CONTRACTOR
CHANGE ORDER
New Transportation Bldg
Project #01123203

Change Order Number: 006

Project:
Mt. Vernon Community School Corp.
New Transportation Center
Hunt Job #01123203

ARCHITECTS SUPPLEMENTAL INSTRUCTIONS #11

FIRST FLOOR LIGHTING PLAN

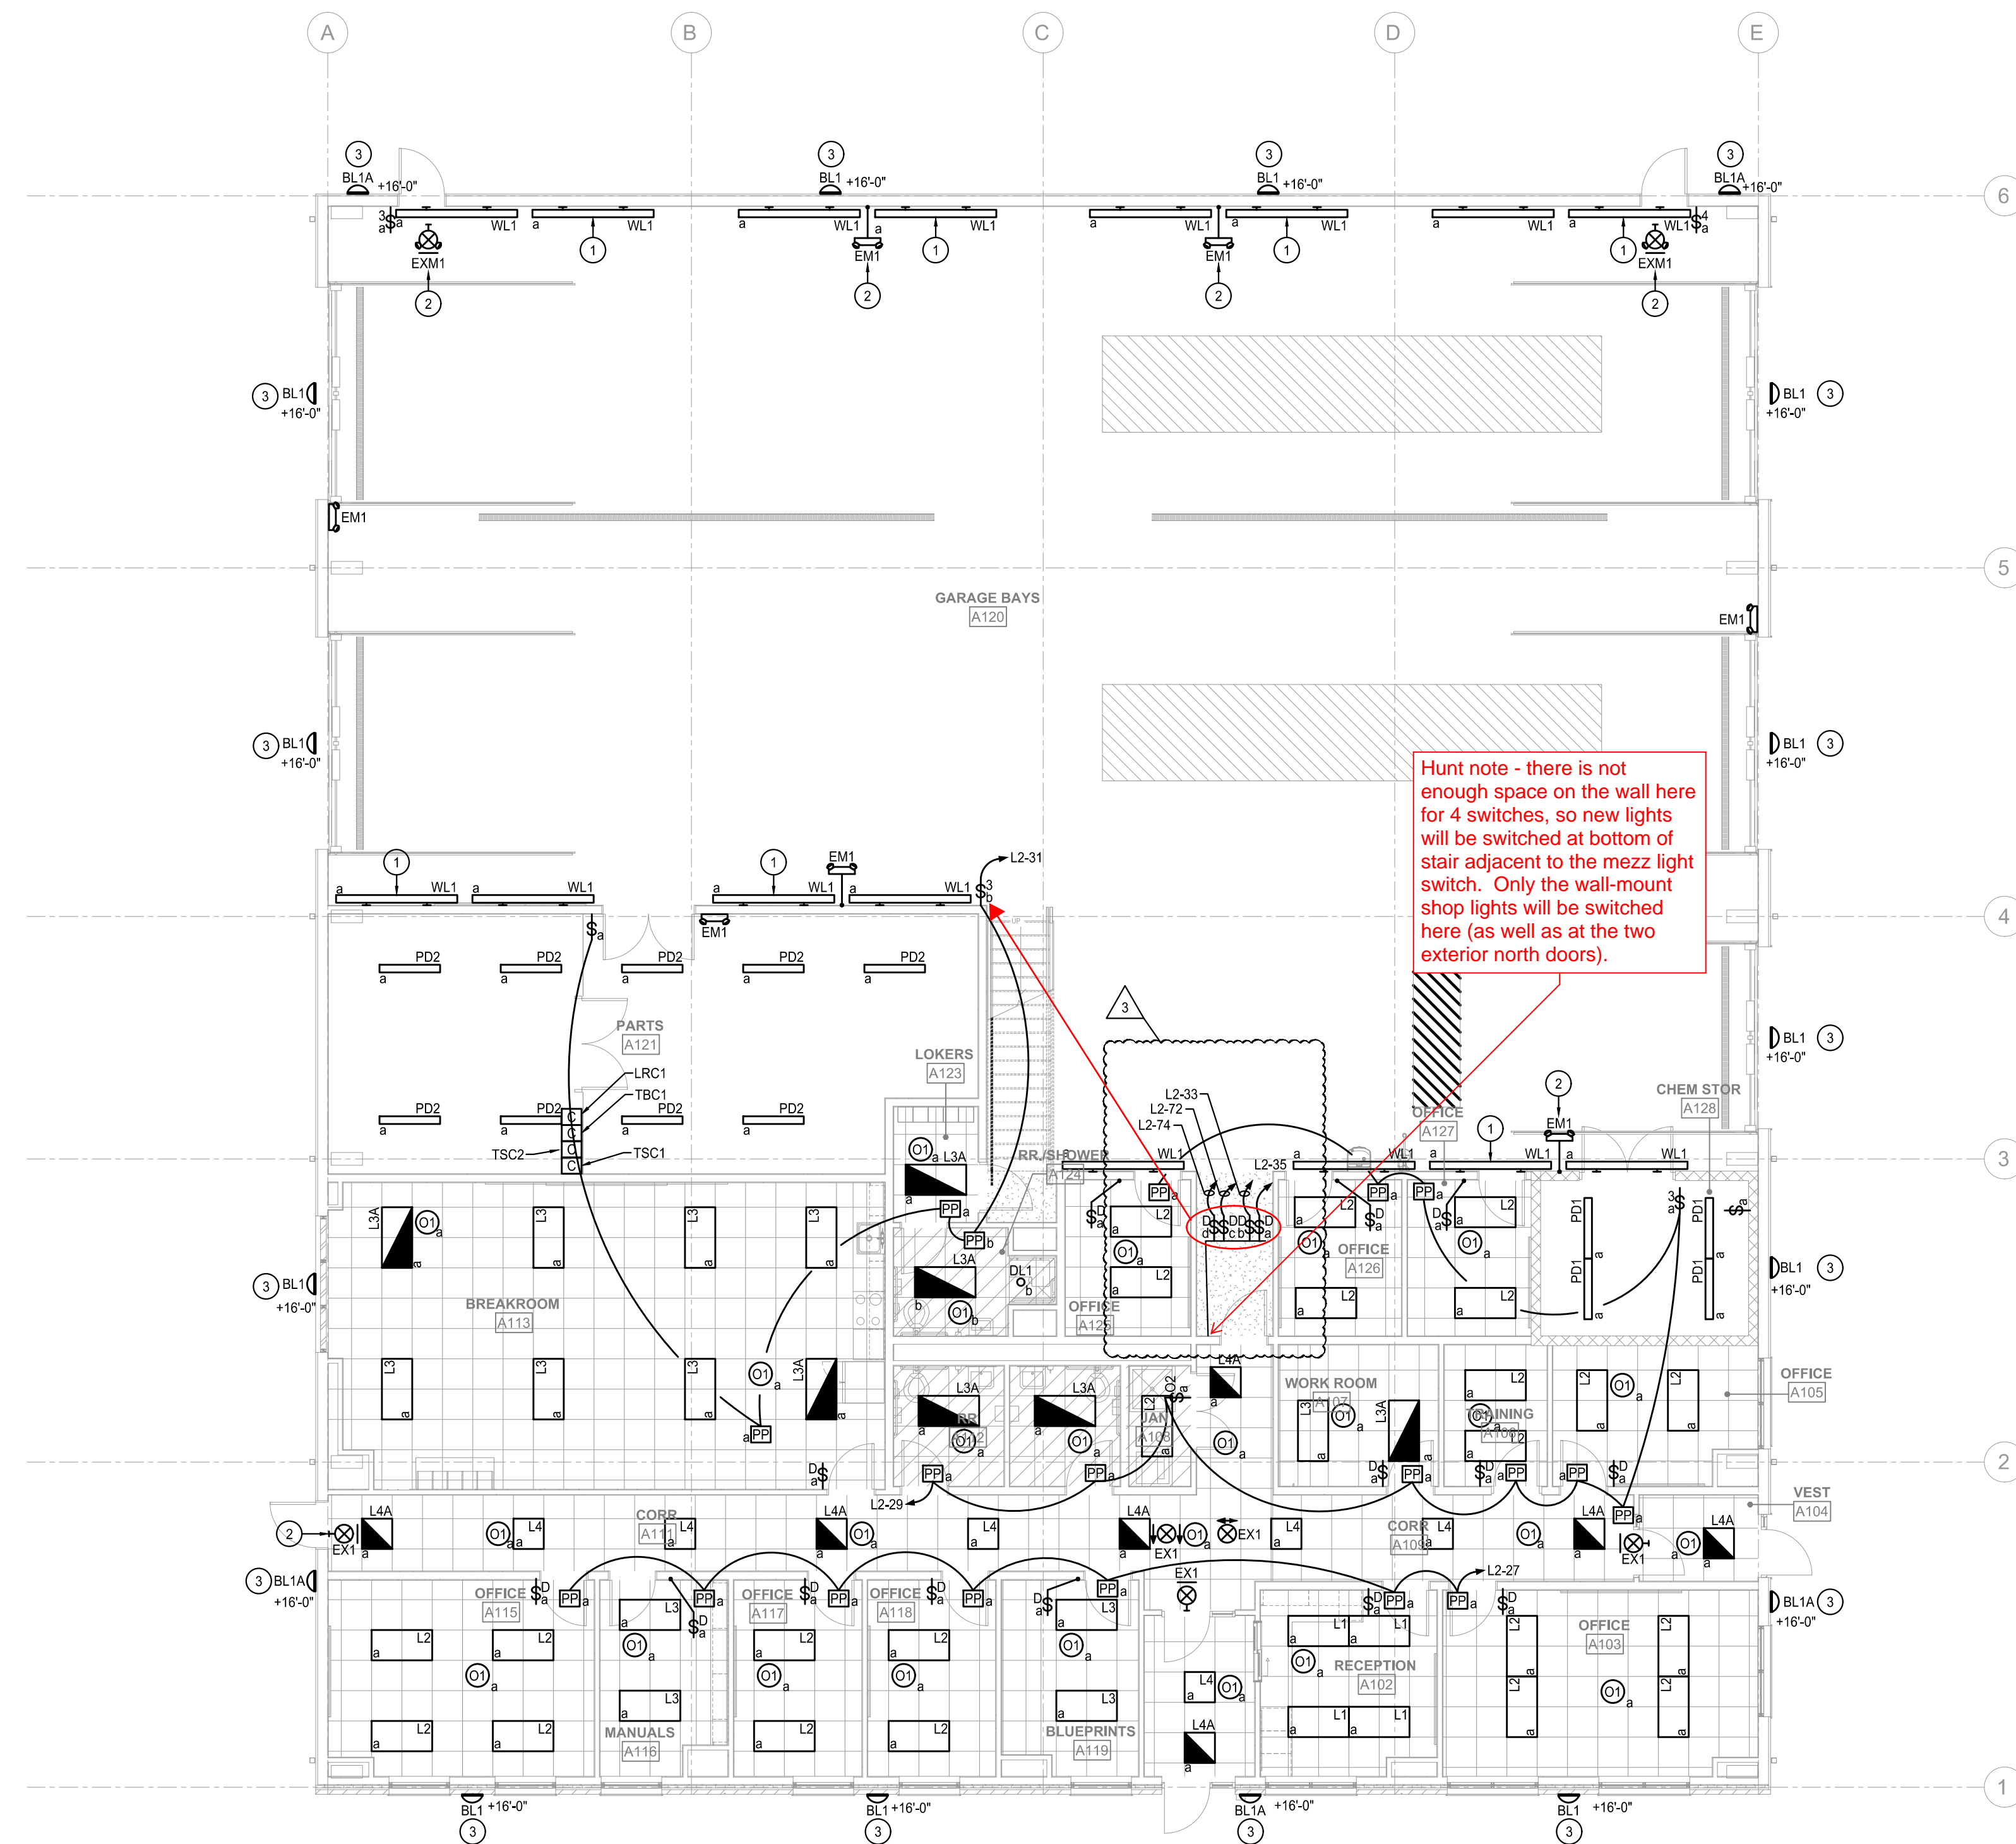
1. Additional overhead lighting in shop area requested by Owner.

1. RM. Add fixtures, associated circuiting and switching for new lighting as indicated in supplemental information drawings E301 and E302.

- PLAN NOTES**
1. MOUNT FIXTURE ON WALL 15'-0" A.F.F. FIXTURE TO BE MOUNTED TO UNSTRUT TO PROVIDE CLEARANCE FOR CONDUIT, PIPING, ETC. SURFACE MOUNTED ON WALL. COORDINATE WITH ALL OTHER TRADES. TYPICAL OF ALL WL1 FIXTURES.
 2. CONNECT EXIT SIGN TO UNSWITCHED SIDE OF BRANCH CIRCUIT SERVING THIS SPACE. TYPICAL OF EXIT SIGNS.
 3. CONNECT FIXTURE TO CONTACTOR TBC1 LOCATED IN ROOM A121. REFER TO DETAIL #9 ON SHEET E502 FOR ADDITIONAL INFORMATION.
